SERVICE BULLETIN

N° **139-677**

ATA 23 - 150 FT AURAL INHIBIT KIT P/N 4G2350F01511, INSTALLATION OF

Through the installation of kit P/N 4G2350F01511 this Service Bulletin gives the operators of AW139 helicopters the option to add a new white STATUS Message “150 FT AURAL INHIB” in the CAS list of MFDs.

Figure 8

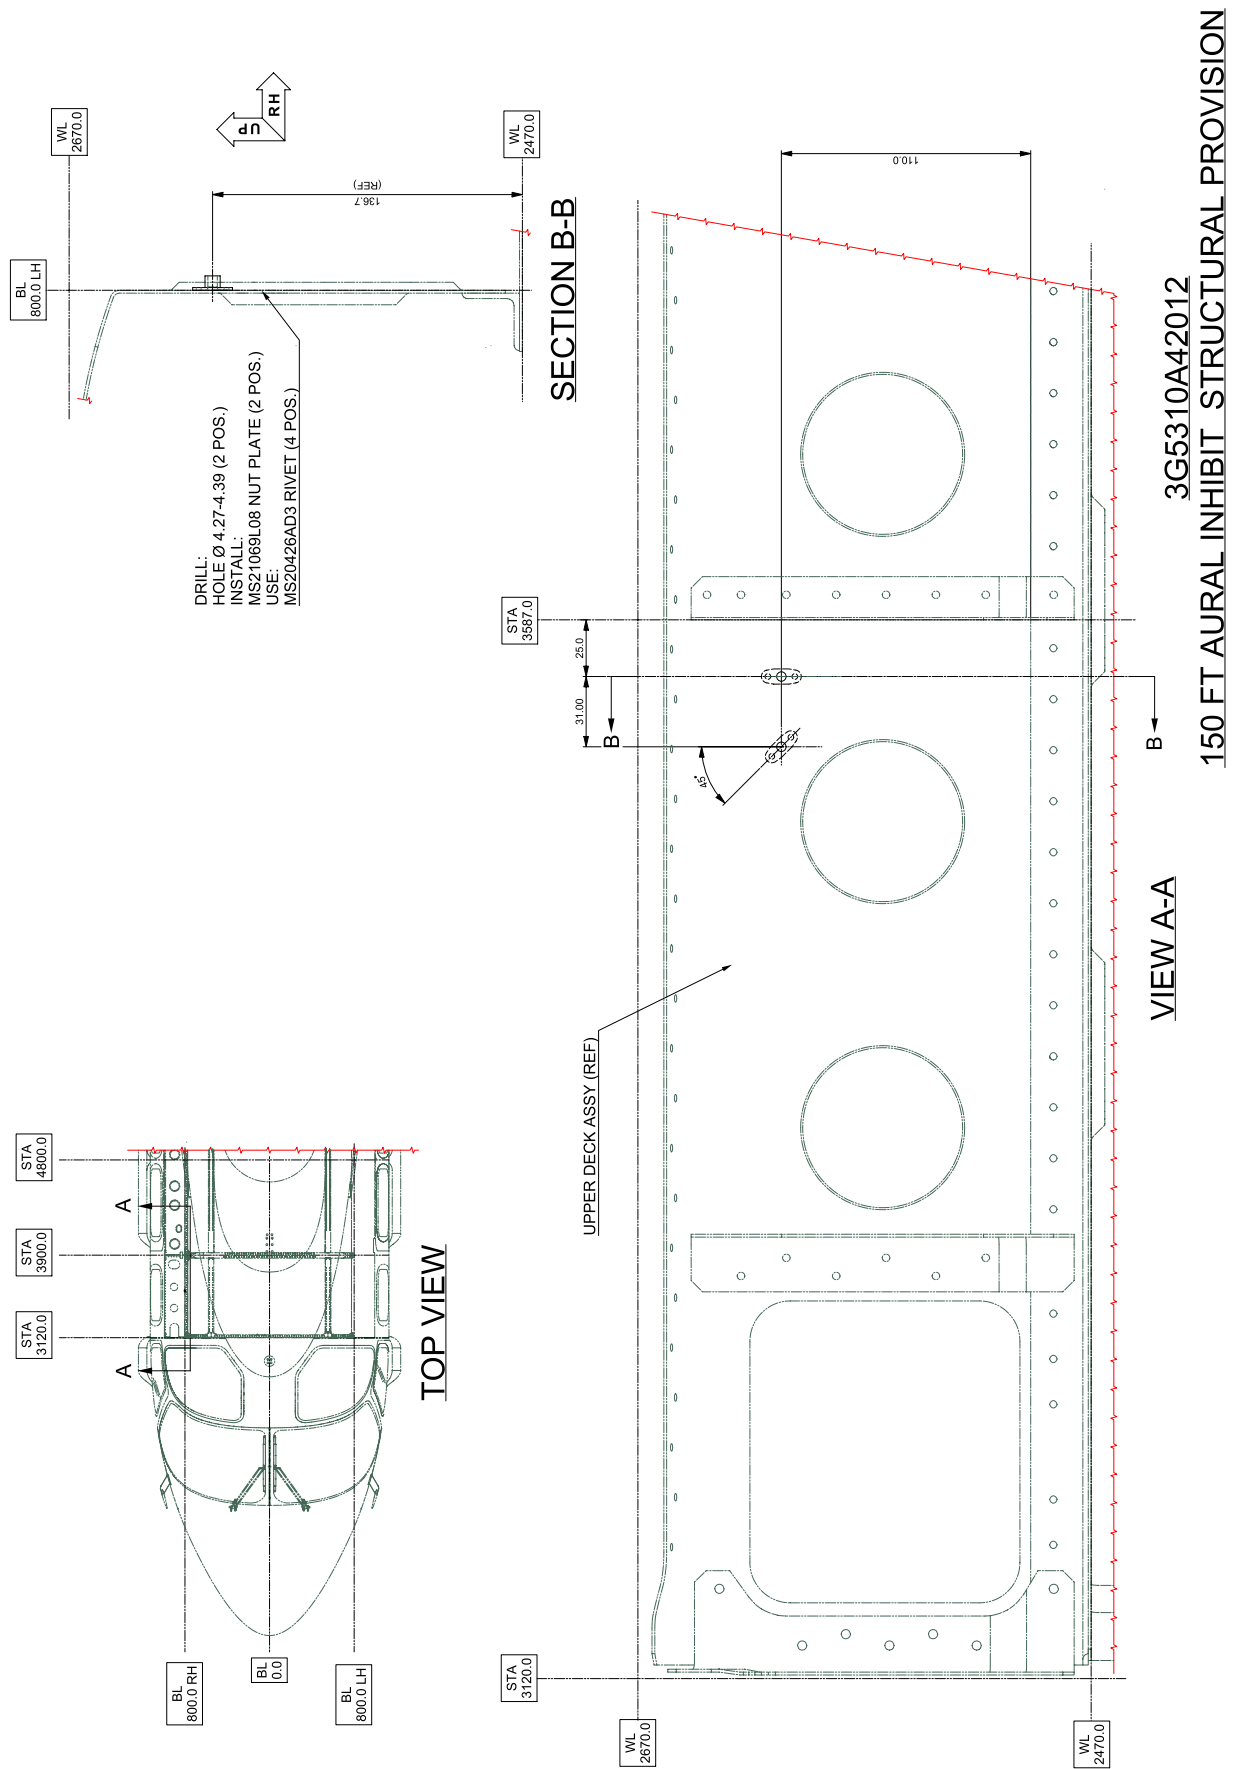
7. With reference to Figure 8 install the 150 ft Aural Inhibit structural provision P/N 3G5310A42012, as follows:
 - 7.1 With reference to Figure 8 Section B-B, mark position of two nut plates to be installed on upper deck.

- 7.2 With reference to Figure 8 Section B-B drill n°2 holes \varnothing 4.27 to 4.39 mm diameter at marked positions and install n°2 nut plates P/N MS21069L08 using n°4 rivets P/N MS20426AD4-3.

Figure 10

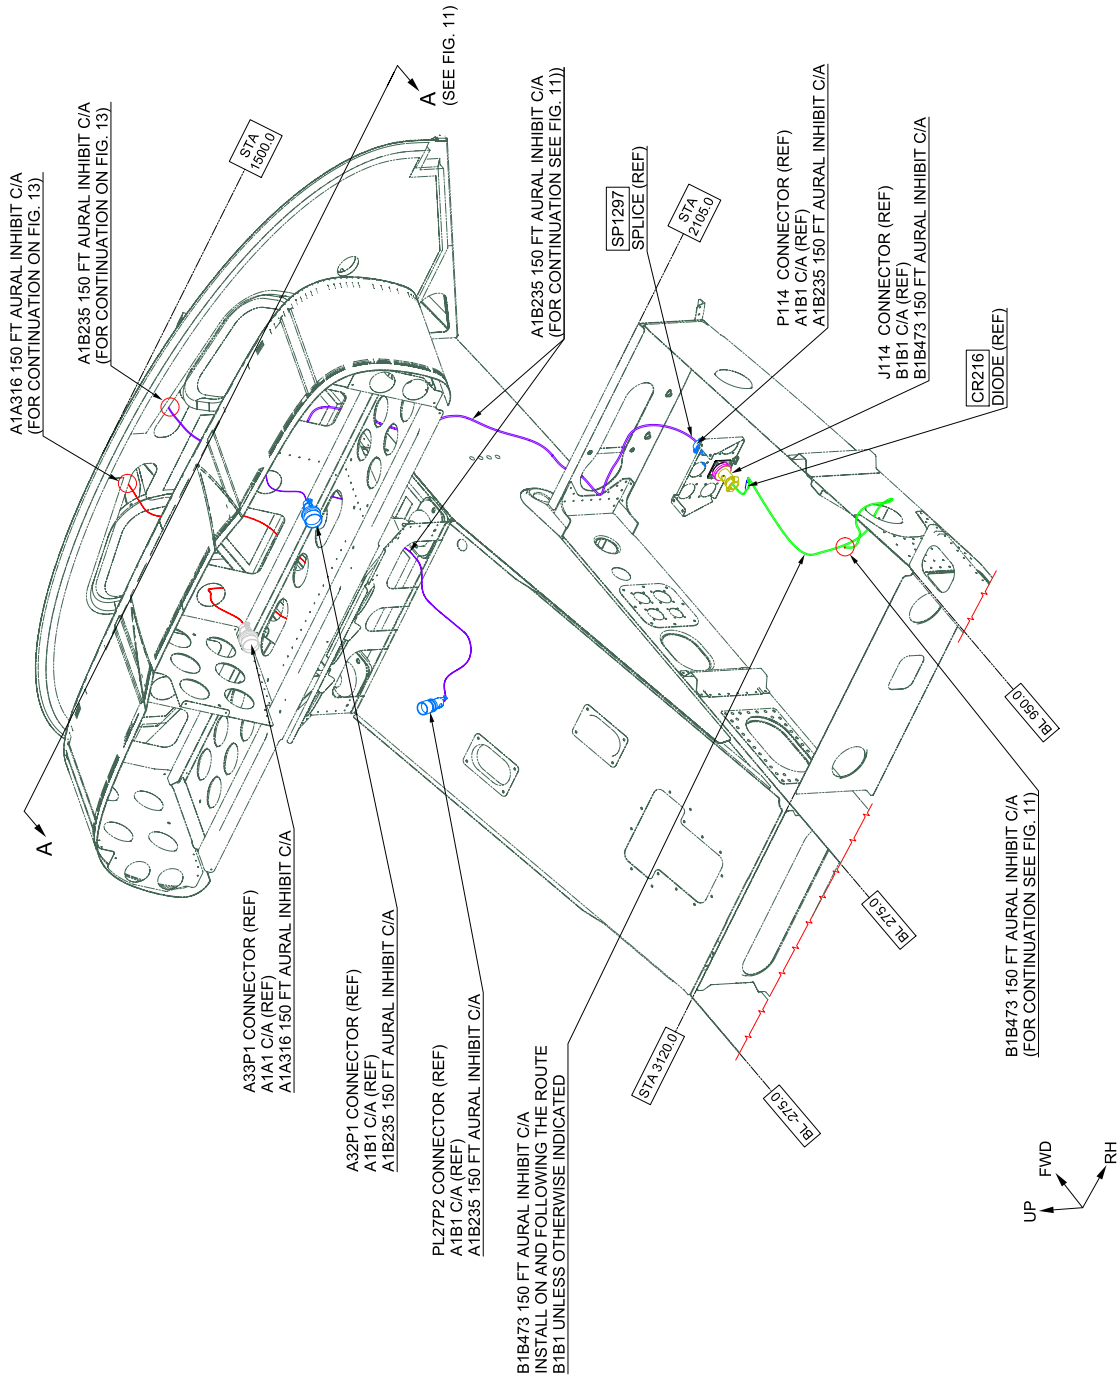
- 8.2 With reference to Figure 10, Figure 13 and Figure 16 Wiring diagram disconnect wire R395A22-G, of route A1B203, laid down between PL27P2 connector of the

- 3G9A01B32501 150 ft Aural Inhibit C/A (A1B325)
 - 3G9B01B47301 150 ft Aural Inhibit C/A (B1B473)
 - 8.7 With reference to Figure 10, Figure 16 wiring diagram and table on Figure 17 make the electrical connections at A32P1 and A33P1 connectors of the Pilot's MFD and Copilot's MFD, at PL27P2 connector of the Miscellaneous control panel and at P114 and J114 sectioning connectors in RH cockpit floor

Figure 15

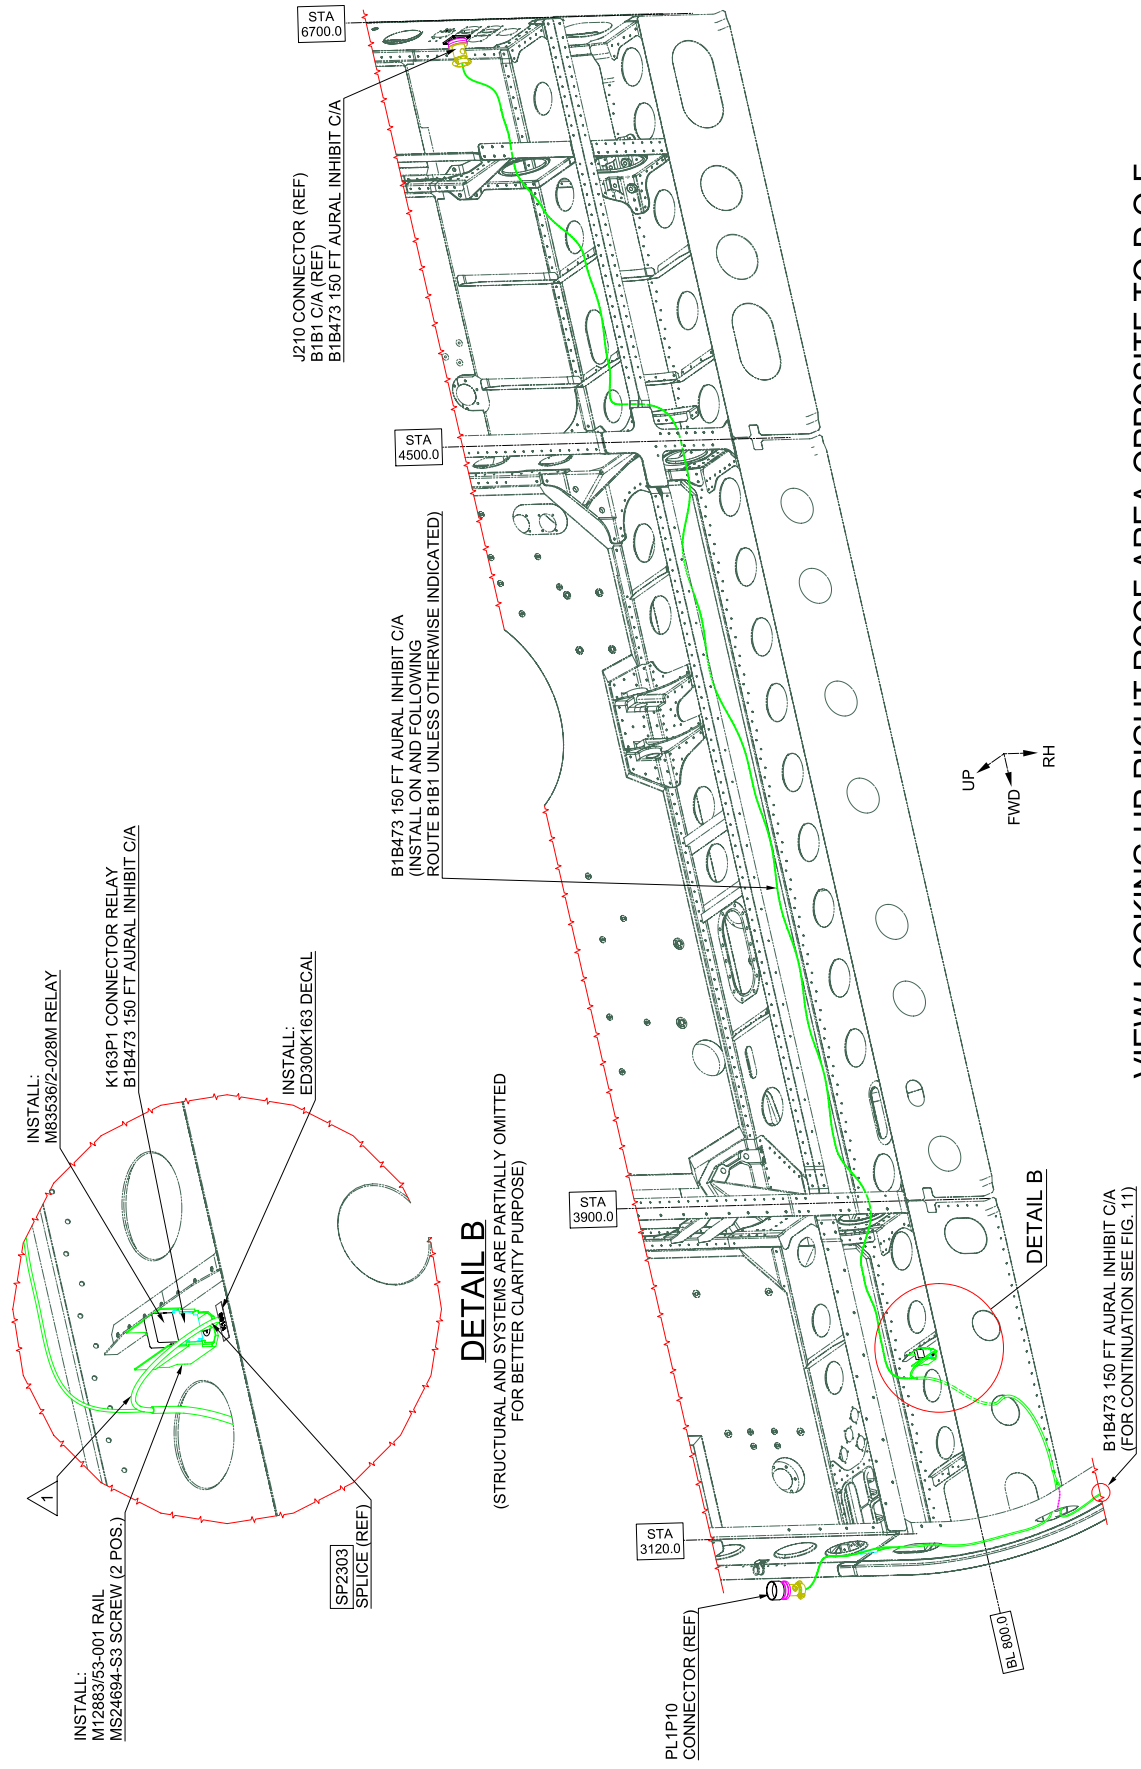
- 8.1 With reference to Figure 5 and Figure 15 Wiring Diagram disconnect wire F100A20-G, of route B1B161, laid down between PL1P6 connector of the Circuit Breaker panel and J52 sectioning connector in cabin roof. Remove wire F100A20-G or stow it in adjacent area.

- 8.2 With reference to Figure 3, Figure 7 and Figure 15 Wiring Diagram disconnect wire R199A22N of route B1B2, laid down between PL27P2 connector of the Miscellaneous Control panel in the interseat console and P108 sectioning connector in cabin floor. Remove wire R199A22N or stow it in adjacent area.

Figure 16

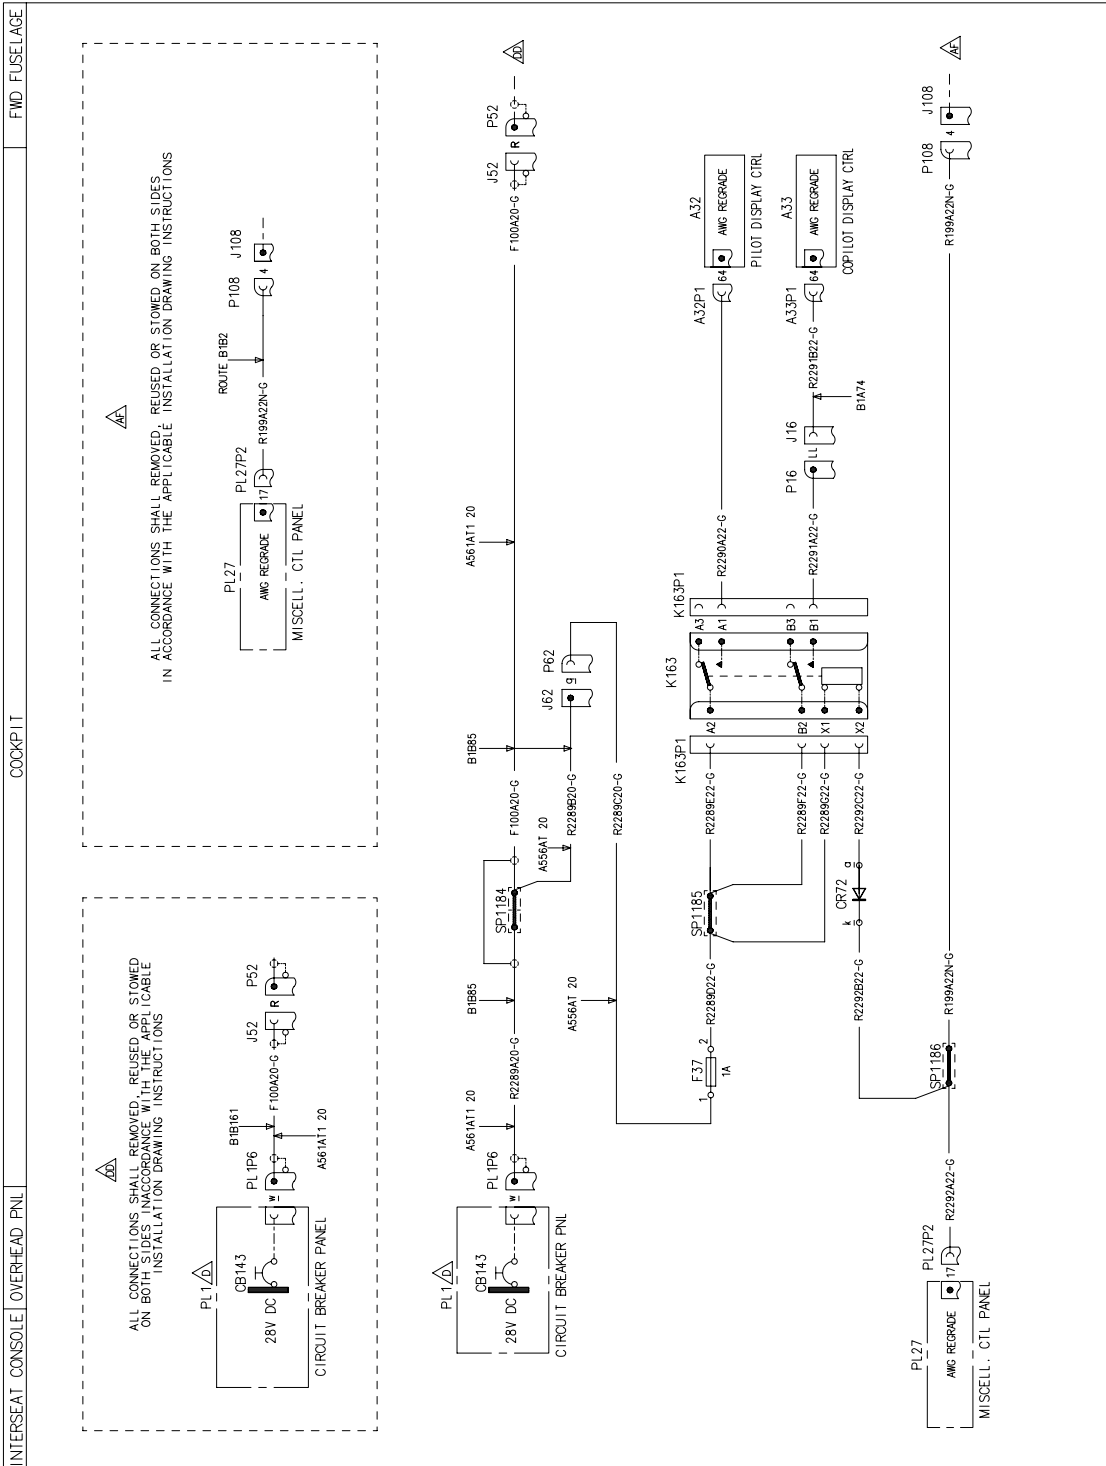
- 8.1 With reference to Figure 9 thru Figure 14 and Figure 16 Wiring Diagram, disconnect wire F30A20-G, of route B1B245, laid down between PL1P10 connector of the Circuit Breaker panel and J210 sectioning connector in cabin roof. Remove wire F30A20-G or stow it in adjacent area.
